MODIFICATION

INDEX

Type 547/RM547

POWER CHASSIS

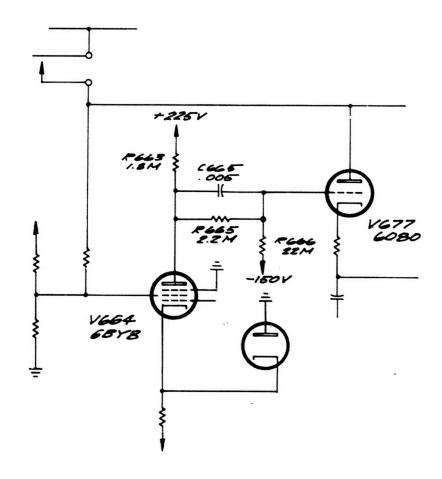
- a) Remove R663, a 1M 1/2W 10% resistor, between CSD-22 and CSE-22.
- b) Remove R667, a 330k 1/2W 10% resistor, from CSD-21 and CSE-21.
- c) Remove the bare wire between pin 7 of V664 and pin 4 of V677.
- d) Connect C665 and R665 in parallel and solder them between CSE-22 and pin 7 of V664.
- e) Install R663, a 1.8M 1/2W 5% resistor between pin 7 of V664 and CSD-22. Insulate the lead to CSD-22 with a piece of #22 tubing.
- f) Install R667, a 300k 1/2W 5% resistor, between CSD-21 and CSE-21.
- g) Replace the #22 wire box strap between CSF-19 and CSF-25 with two #22 box straps between CSF-19/22 and CSF-22/25.
- h) Solder R666, a 22M 1/2W 5% resistor, between CSF-22 and CSE-22.
- i) Replace R677, on the shunt resistor bracket, with a 2k 25W 5% resistor.

REAR PANEL POWER REQUIREMENTS MARKING

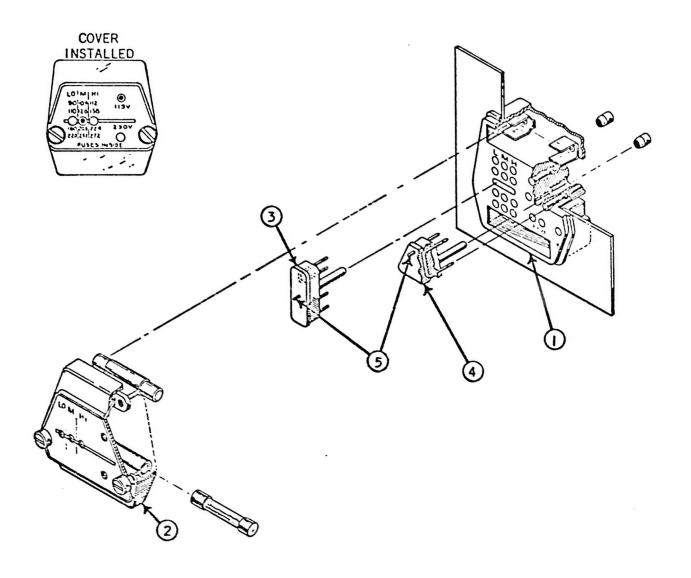
A Line Voltage Selector switch (SW602) was added to the rear panel. The new switch assembly includes a 115V fuse, and a 230V fuse to eliminate the need for a fuse holder. The primaries of the power transformer (T601) were changed to accommodate the Line Voltage Selector switch, and the rear panel power requirement markings were changed.

Before

After

SWEEP CHASSIS

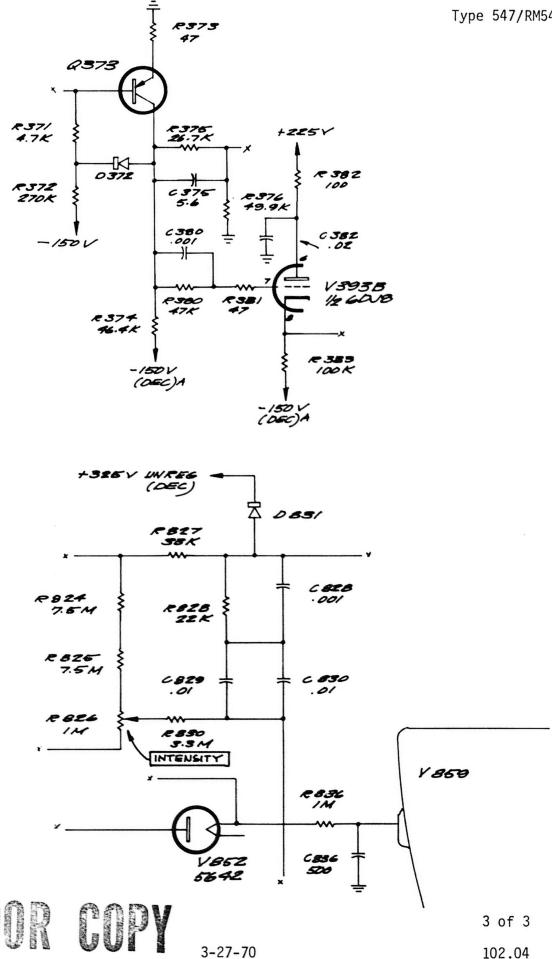
- a) Lift end of D372 at CSD-43.
- b) Remove #22 bare wire strap between CSD-42 and CSD-43.
- c) Install R380, 47k 1/2W resistor, between CSD-43 and collector of Q373 directly below.
- d) Solder loose end of D372 to CSD-42.
- e) Lift components from CSD-44 thru -47 to gain access to R381, 47Ω 1/4W resistor between CSD-45 and pin 7 of V393B.
- f) Relocate R381 between pin 7 of V393B and CSD-43 using a new 47Ω 1/4W resistor.
- g) Reconnect components lifted in step e.
- h) Install C380, a 1000pF capacitor, between CSD-43 and CSE-43.

- i) Remove #22 bare wire strap between CSE-6 and CSG-1.
- k) Relocate lead of R827, 33k 1/2W resistor, to CSE-3 from CSG-1.
- m) Install D831, 1N3195 diode, between CSF-1 and CSG-1 (cathode to CSG-1).
- n) Install a #22 white wire between CSG-1 and C802 center terminal. C802 is located on the vertical portion of the F & I chassis.

FIG. 1.

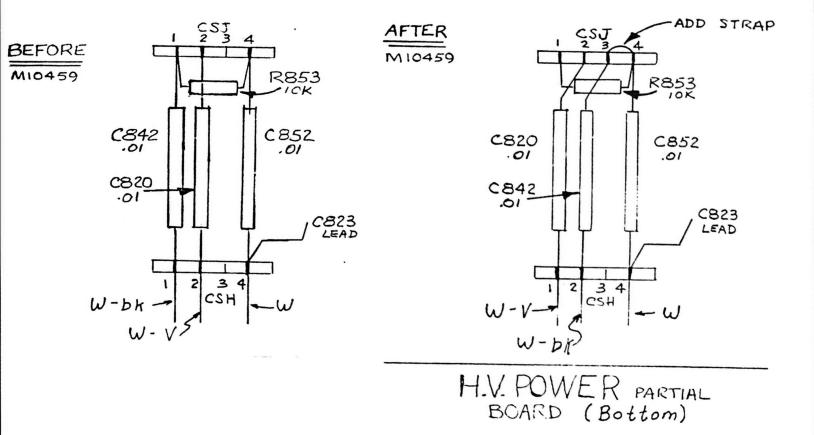
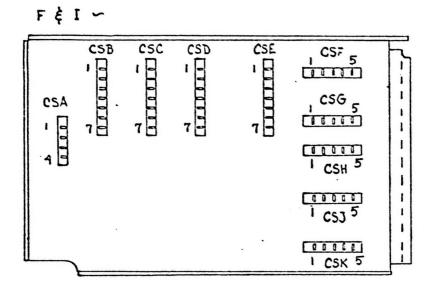
- a) Replace R806, a 100k 1/2W 10% resistor, located between CSJ-4 and CSK-4, with an 82k 1/2W 10% resistor. See Fig. 1.
- b) Rewire the connections of C842 as shown in attached schematic and procedure. See Fig. 2.

Fig. 1. Installing Light Reflector Ring and Plate.

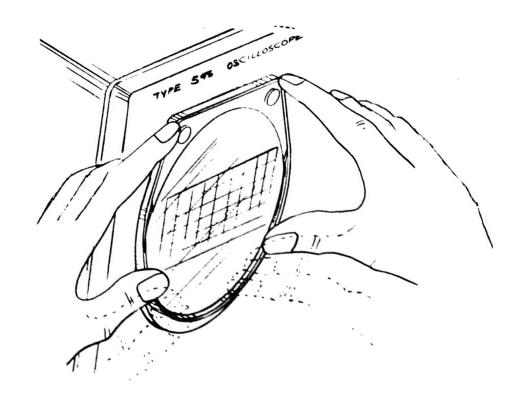
- () 14. Turn on the oscilloscope. Obtain a free-running sweep on the crt.
- () 15. Check the alignment of the trace with the graticule lines. If the trace is not parallel with the graticule lines, align the trace with the TRACE POSITION control.
- () 16. Install the new light reflector plate, the light reflector ring, the graticule mask, and the graticule bezel as shown in Fig. 1 and Fig. 2. To install the light reflector ring and plate, hold the ring in place with the forefingers of both hands as shown in Fig. 1. Then slide the thumbs down to snap the bottom of the ring in place.

FIG. 4
A SWEEP TRIGGER
Top components after mod

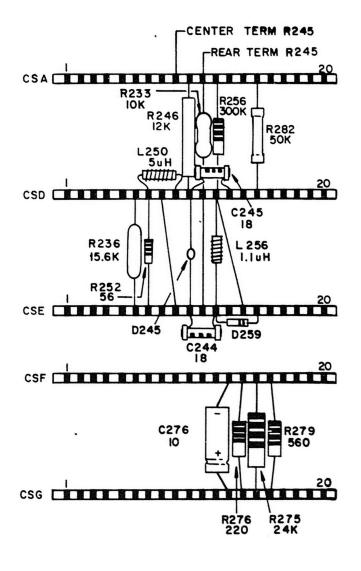
- Refer to Figs. 3 and 4 for steps 47 through 86.
- () 47. ⊕ Install a #22 bare wire between CSD-17 and the adjacent ground solder lug.
- () 48. ⊕ Install a #22 bare wire between CSA-10 and the adjacent ground solder lug.

FIG. 6
B SWEEP TRIGGER
Bottom components before mod

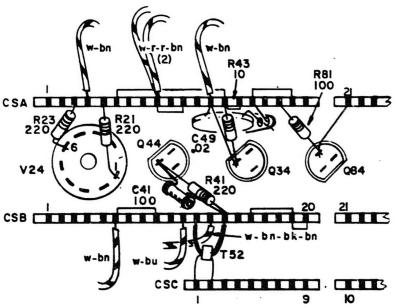
- B. TIME BASE B TRIGGER CIRCUIT ONLY
 Refer to Figs. 5 and 6 for steps 1 through 38.
- () 1. Remove R44, a 10Ω 1/4W 1% resistor, located between CSA-6 and CSB-6.

FIG. 1

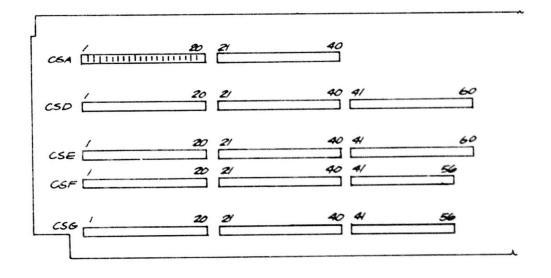
Refer to Fig. 1 for ceramic strip locations.

- Unsolder D286, a diode connected between CSD-22 (CSD-21 in type 544) and CSD-25, or pin 1 of V291.
- () 2a. If D286 was connected to pin 1 of V291, relocate the end of the resistor from CSD-25 to CSD-26 and remove the bare wire between CSD-25 and CSD-26.

FIG. 4

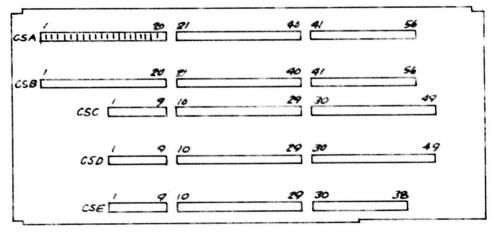
Refer to Fig. 4 for ceramic strip location.

- () 1 Unsolder and remove 586 located between CSA-28 and CSA-30 or between CSA-27 or CSA-28 and pin-1 of V91.
- () If D86 was connected between CSA-28 and CSA-30 remove the ware wire between CSA-30 and pin-1 of V91.
- () 2. For Types 546 SN 100-962, FM546 SN 100-499 and 547 or PM547 SN 190-6739. Unsolder the end of R62 at CSA-21 (to be reconnected in later step to new Q84 socket) and remove the bare wire between CSA-21 and Q84 base.
- () 3. Unsolder and remove the following have wires:
- Between CSA-27 and Q103 emitter.
- () Retween CSA-29 and Q103 base.
- Between CS8-31 and Q103 collector.
- () 4. Unsolder the leads from Q84 socket
